DEVELOPMENT REVIEW BOARD REPORT

75-DR-2005
Casa Del Encanto

Request for approval of a site plan and elevations for addition of a 2nd floor to an existing retail building.

A-1

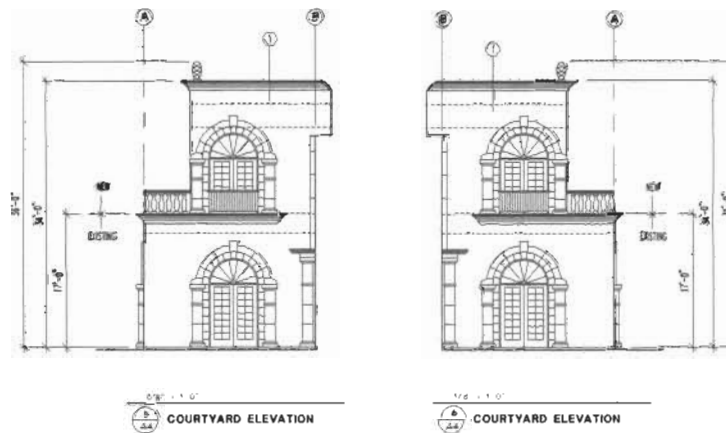
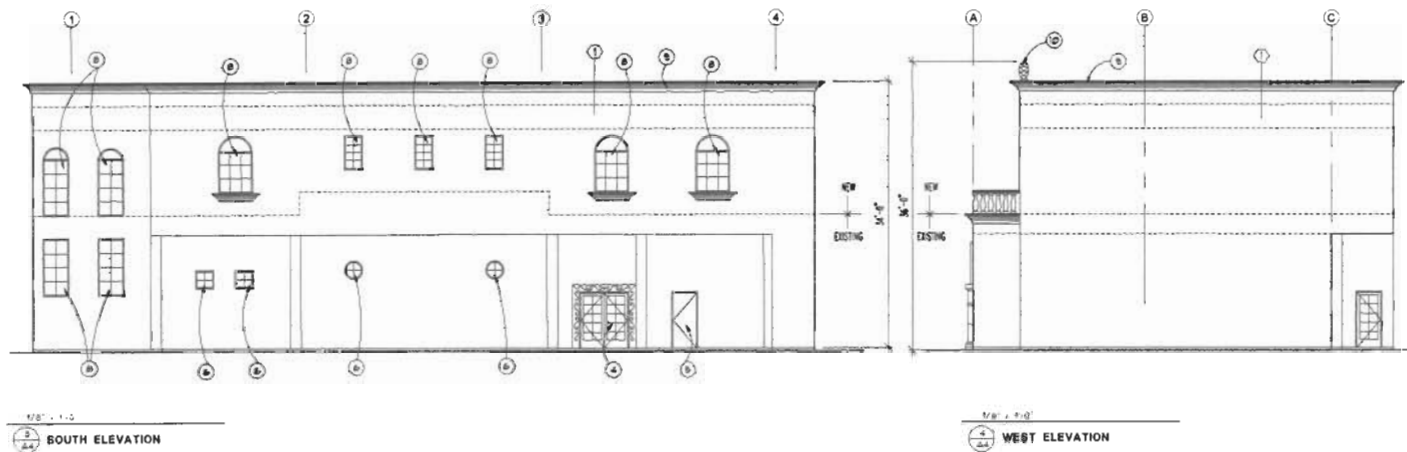
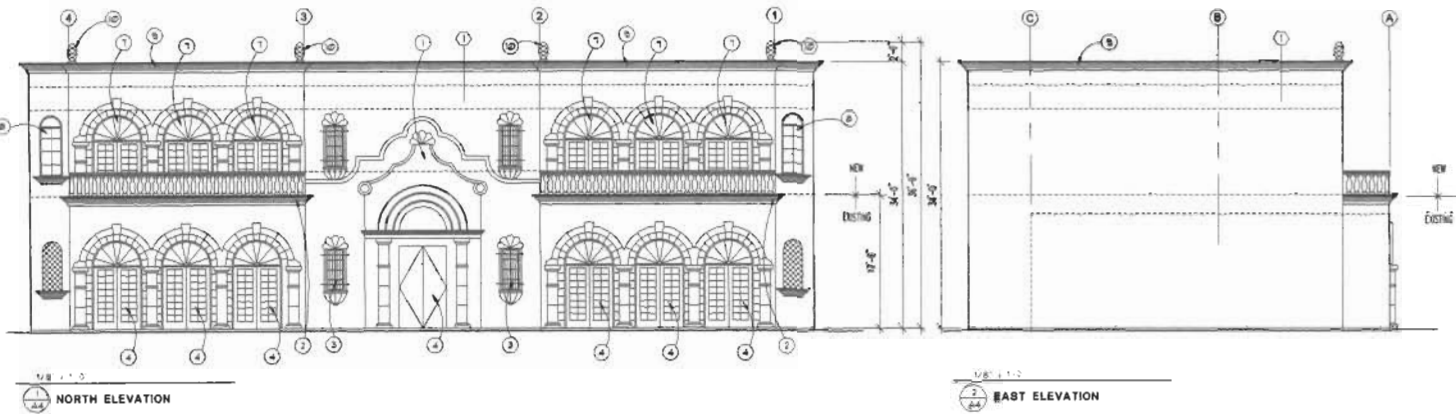
The applicant is matching the existing stucco façade and paint, presently seen on the structure, for the addition to the second story. The skin of the building is a smooth stucco, painted in an auburn color (Frazee “Spiced Rum”), and uses a natural cantera stone (light off white color) to frame the arched windows on the ground level. The proposed second floor will be comprised of the same building materials and color palate, using the canterra stone to frame similarly shaped arched windows and doors which will exit on to the proposed patio space; which will then incorporate a natural stone railing to match the columns and window framing. Finally, the applicant is proposing the same stucco façade and color, and a natural stone cap to wrap around the top of the building.

1. Except as required by the City Code of Ordinances, Zoning Regulations, Subdivision Regulations, and the other stipulations herein, the site design and construction shall substantially conform to the following documents:
 - a. The location and configuration of all site improvements shall be constructed to be consistent with the site plan submitted by Tebo, LLC with a date of 12/16/05 by City staff.
 - b. Architectural elements, including dimensions, materials, form, color, and texture, shall be constructed to be consistent with the building elevations submitted by Tebo, LLC with a date of 08/26/05 by City staff.
